WATERLOO METRO QUARTER CENTRAL PRECINCT

SSD-10439 - RESPONSE TO SUBMISSIONS

SOLAR ACCESS

Floor Plan - Level 3-19

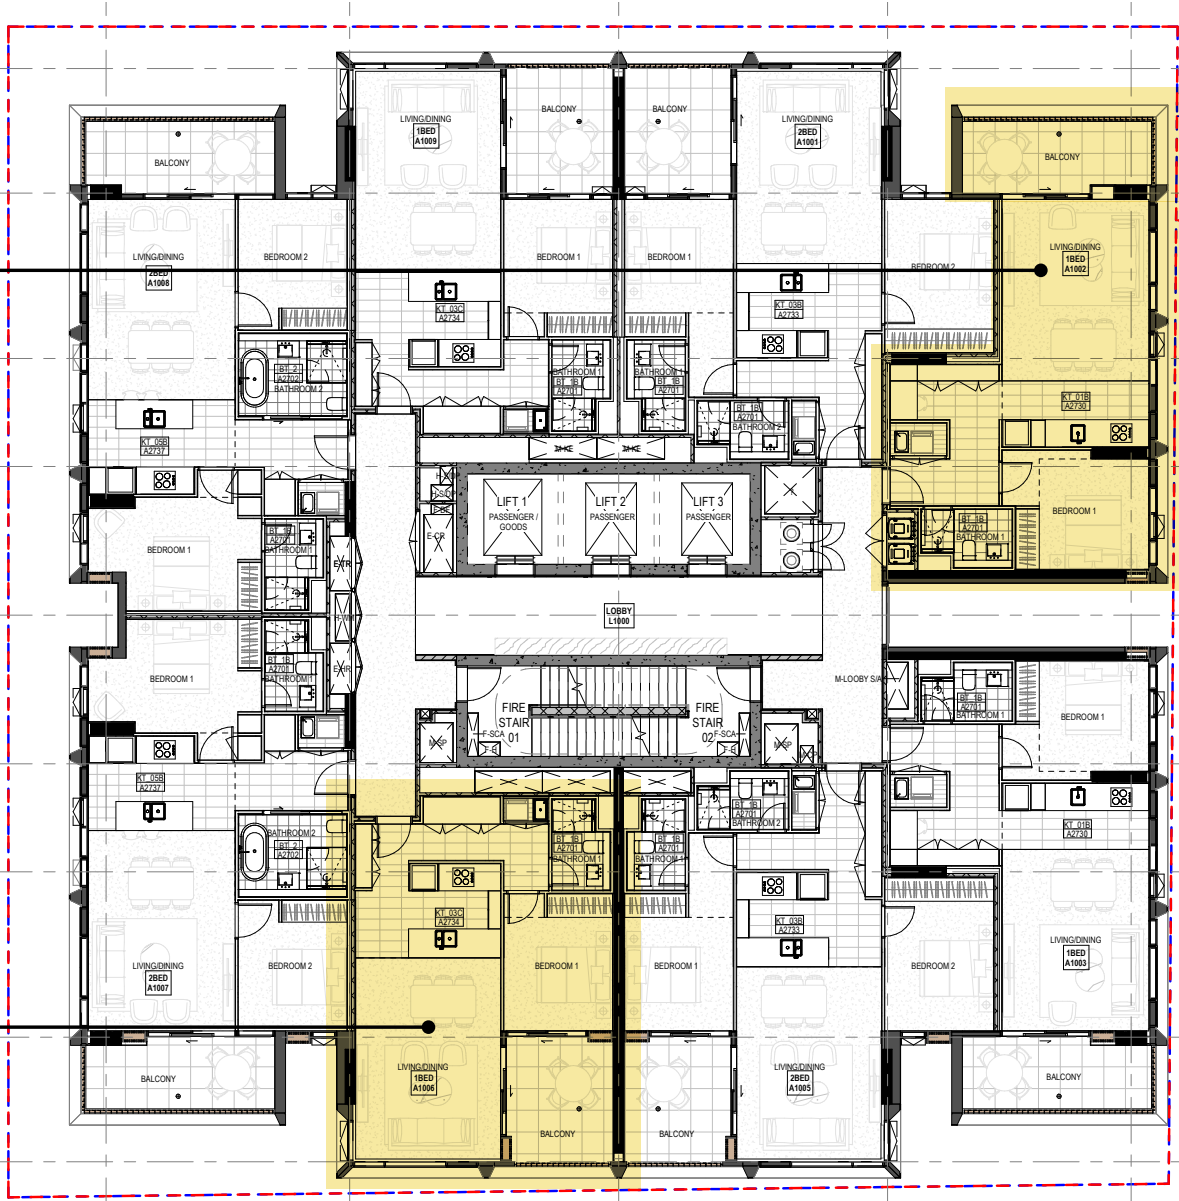
Living room of the South East 1 bedroom apartment achieves 1sqm direct sunlight for 1.5 hours. Potential for improvement.

Living room of the North West 1 bedroom apartment complies with ADG solar. Potential to reshape the facade to allow the POS to also comply.

POS of the east facing 2 bedroom apartment complies with ADG solar. Potential to reshape the living room to allow the living to also comply.

Floor Plan - Level 20-21

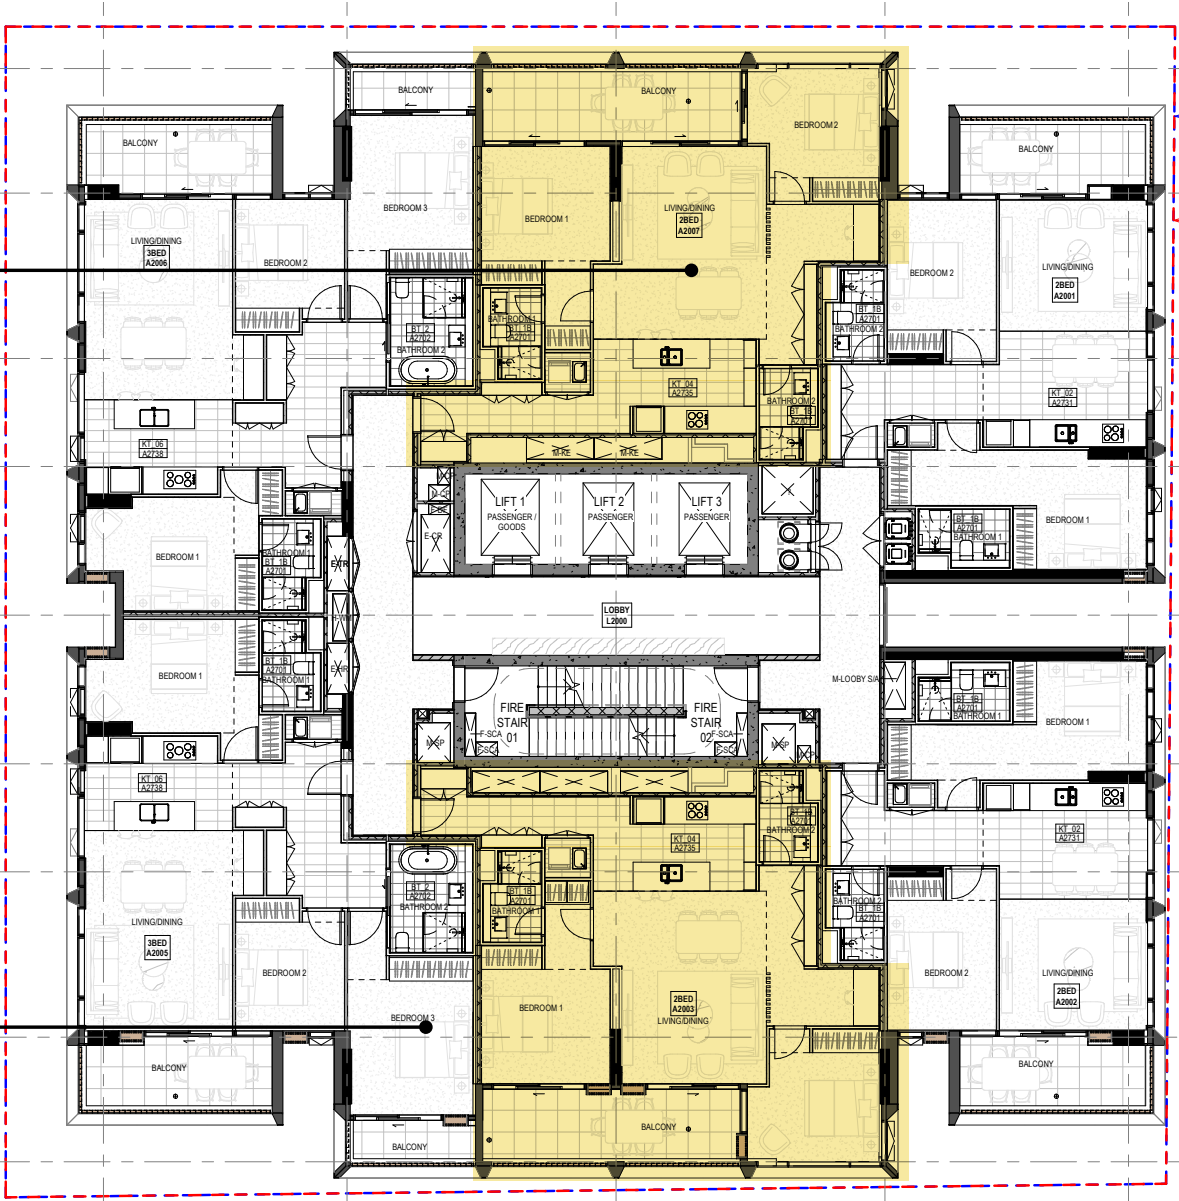
Applying the east change to west apartment will see potential improvement in solar access to both the living room and POS.

SOUTH EAST APARTMENT

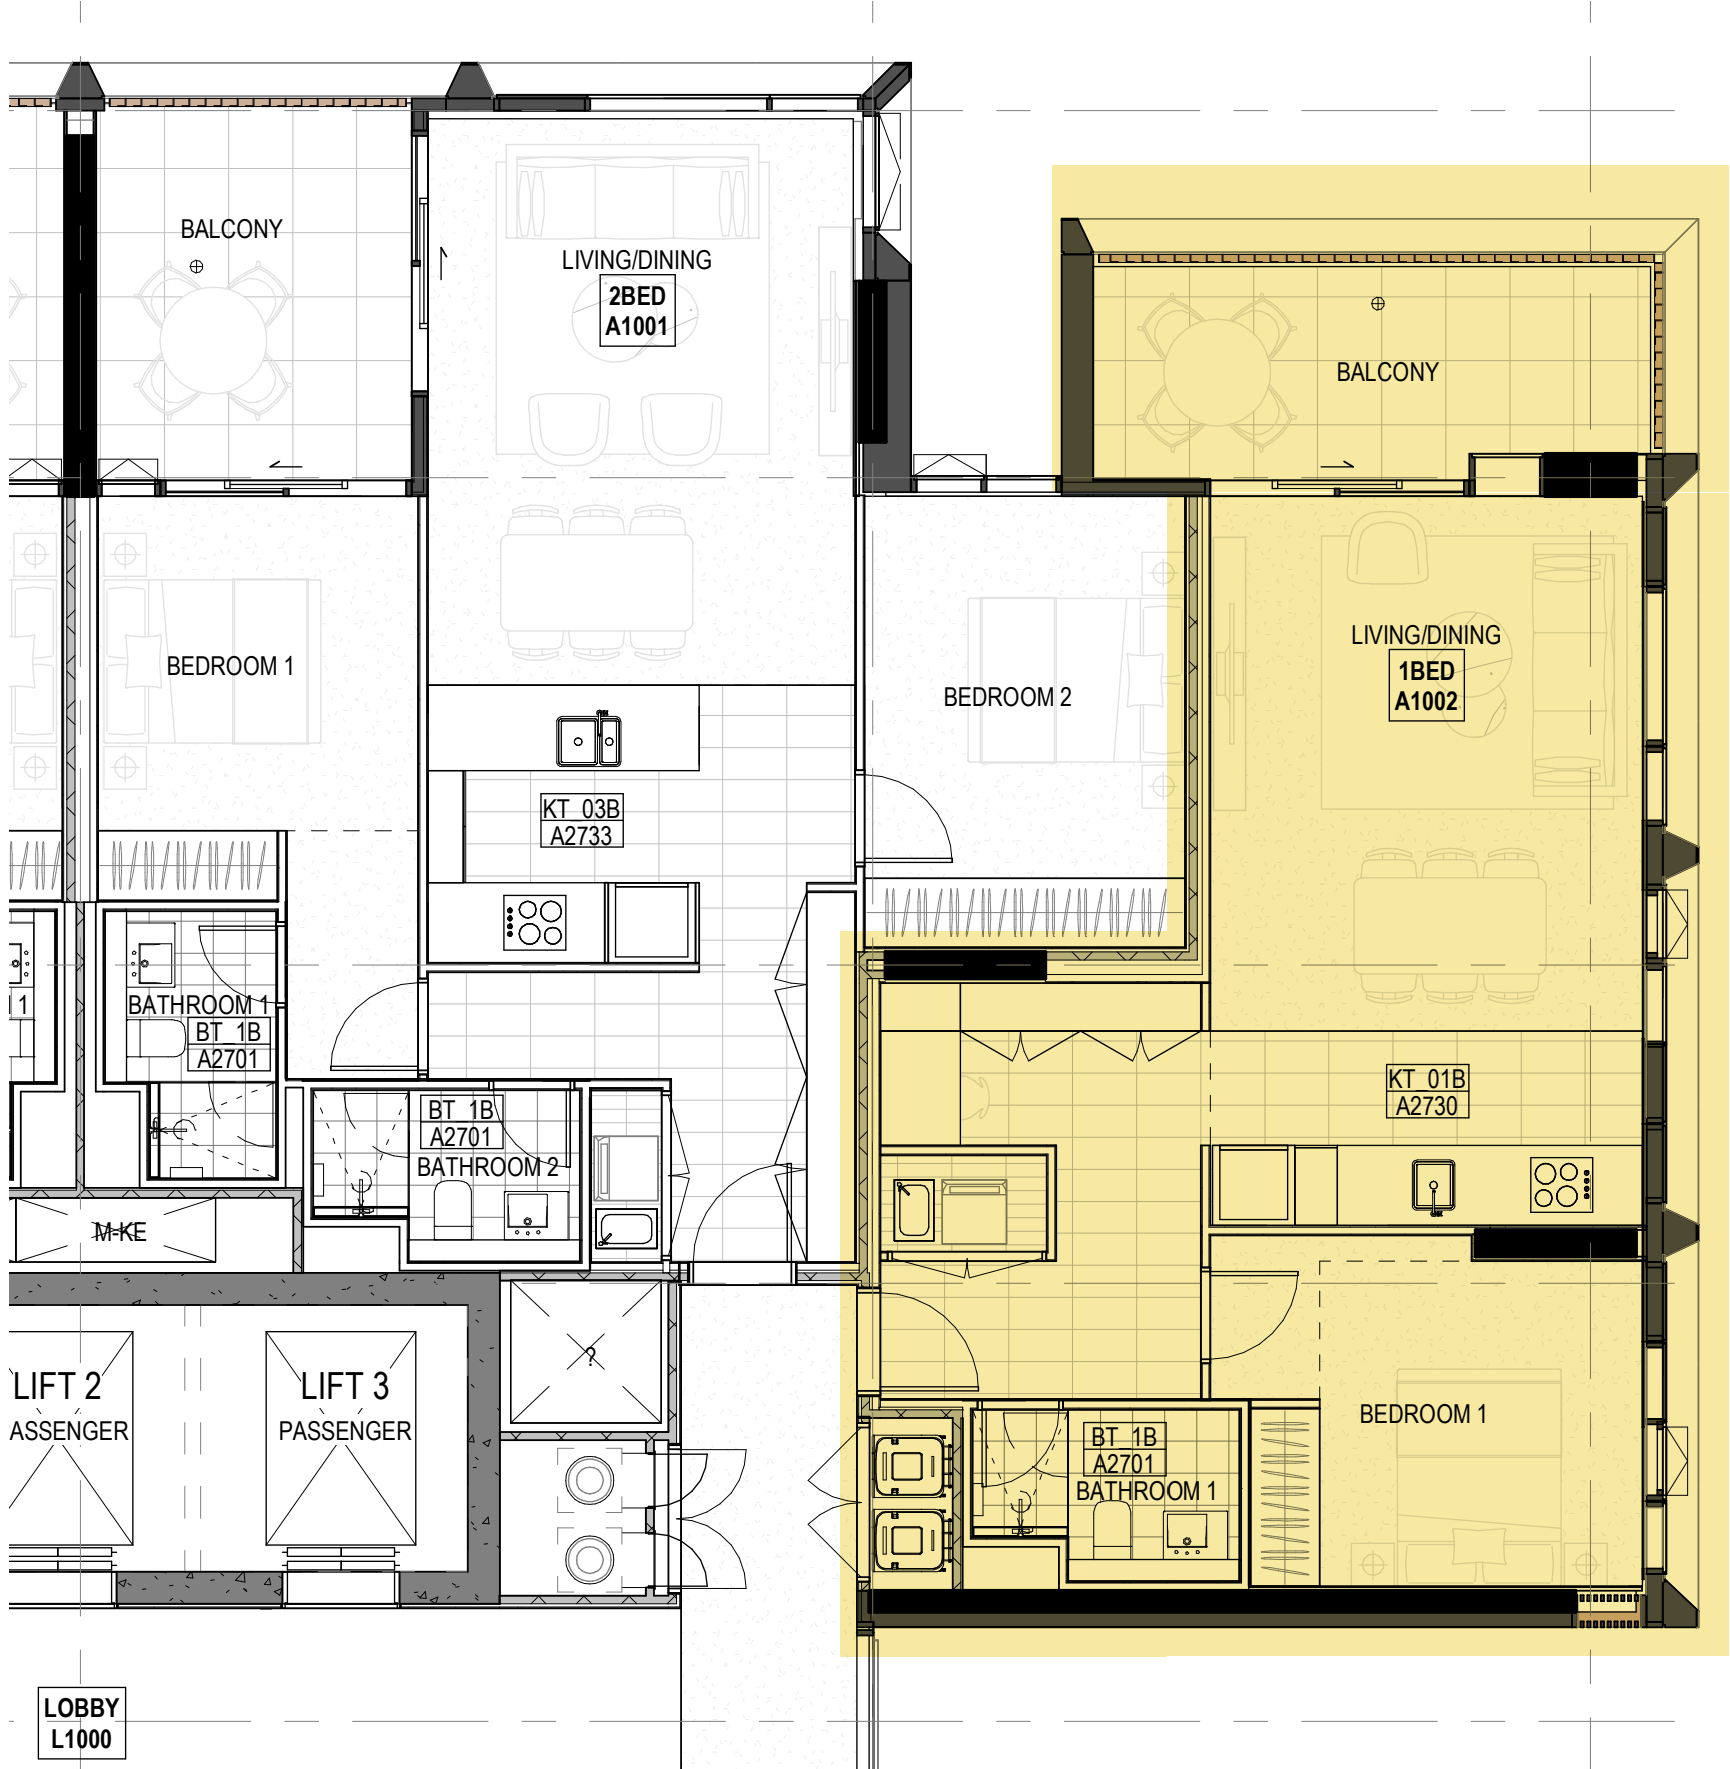
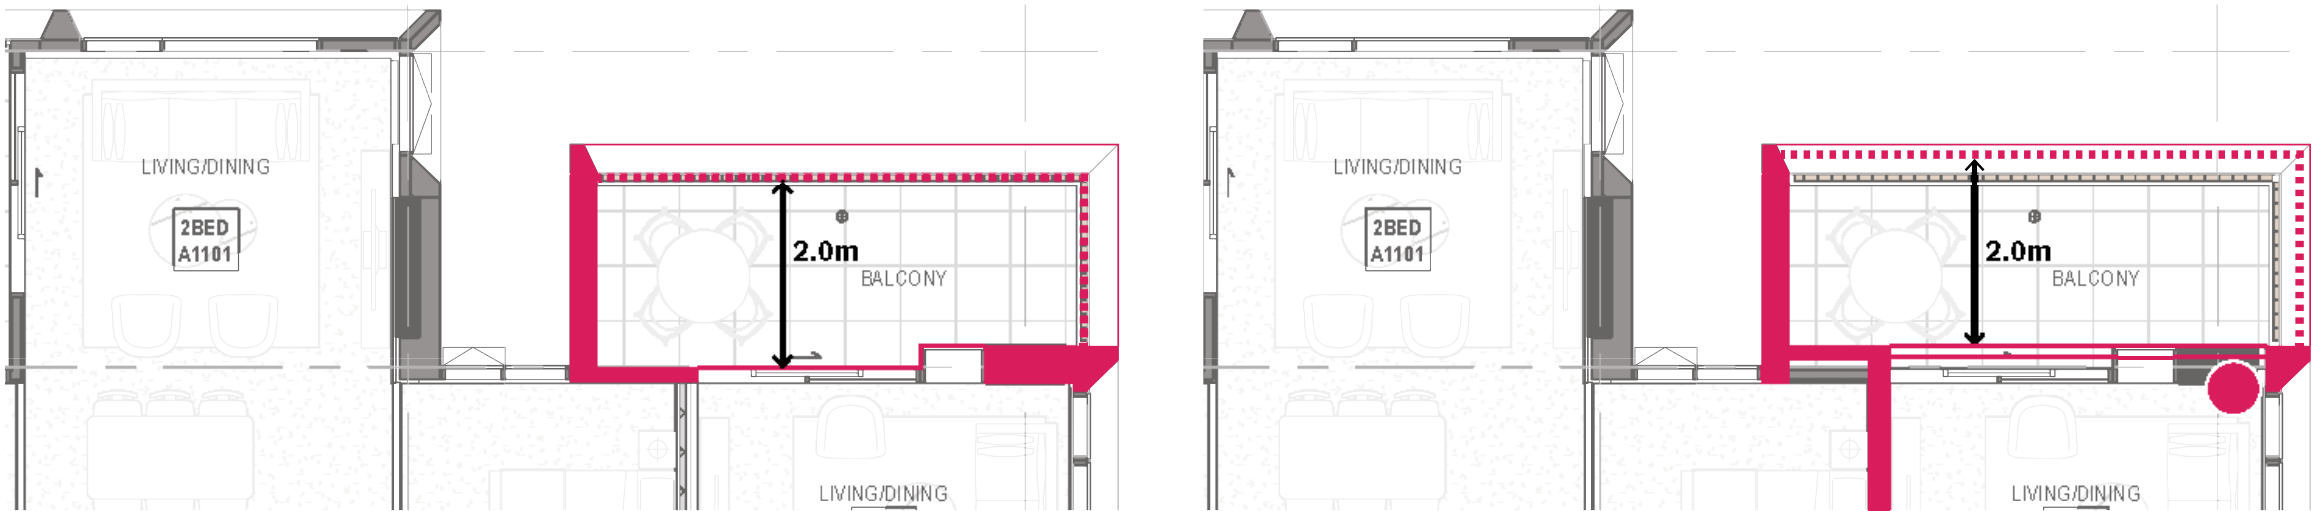
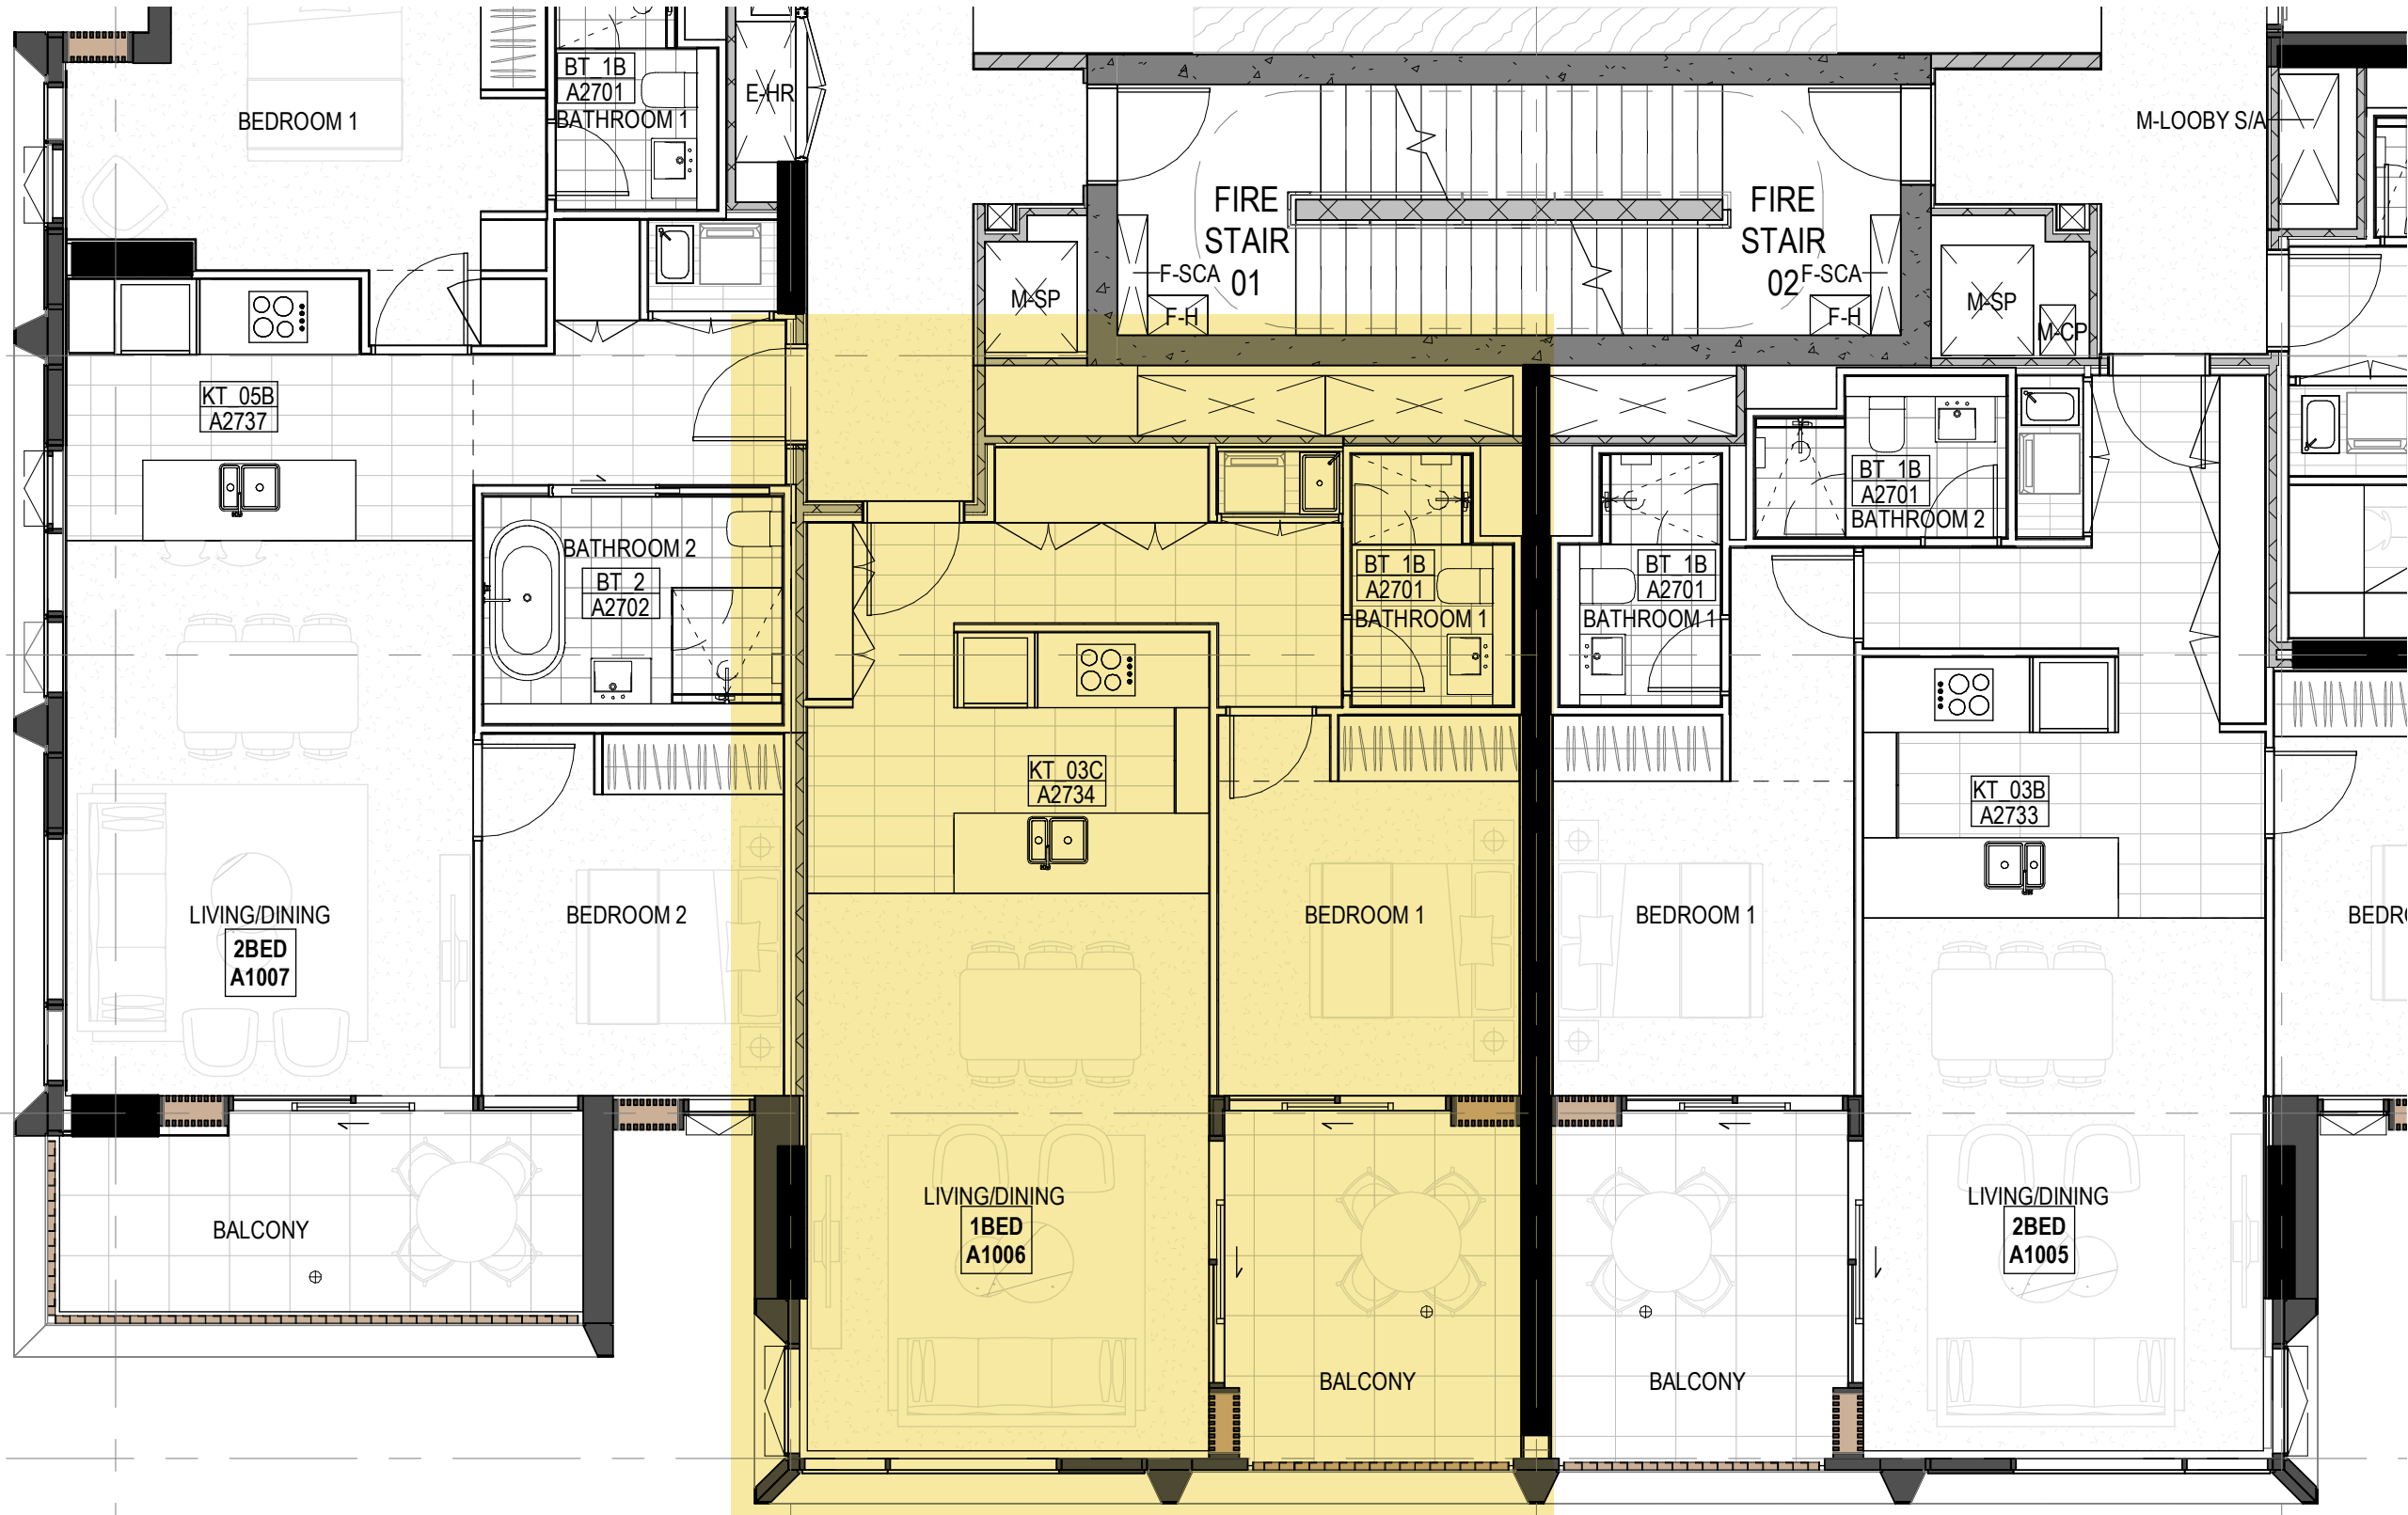
The south east apartment recieves great morning sun from 7:10am mid winter.

_Opportunity to improve solar access of the living room while considering overshadowing to Alexandria Park, POS depth and architectural expression.

Proposed Scheme - Balustrade and Living Glazing Push Out 240mm

- _Maintain 2 metres minimum POS depth
- _Re-oriented column to allow wider opening

The proposed scheme improves the solar access to the living room of the south east apartment by 10mins compared to the DA massing where both living room and POS have access to a minimum of 1 sqm solar for 1 hour and 40 mins mid winter.

An additional 19 apartments between level 3 and level 21 achieve the intent of ADG to maximise solar access to both living room and POS between 9:00am and 3:00pm.
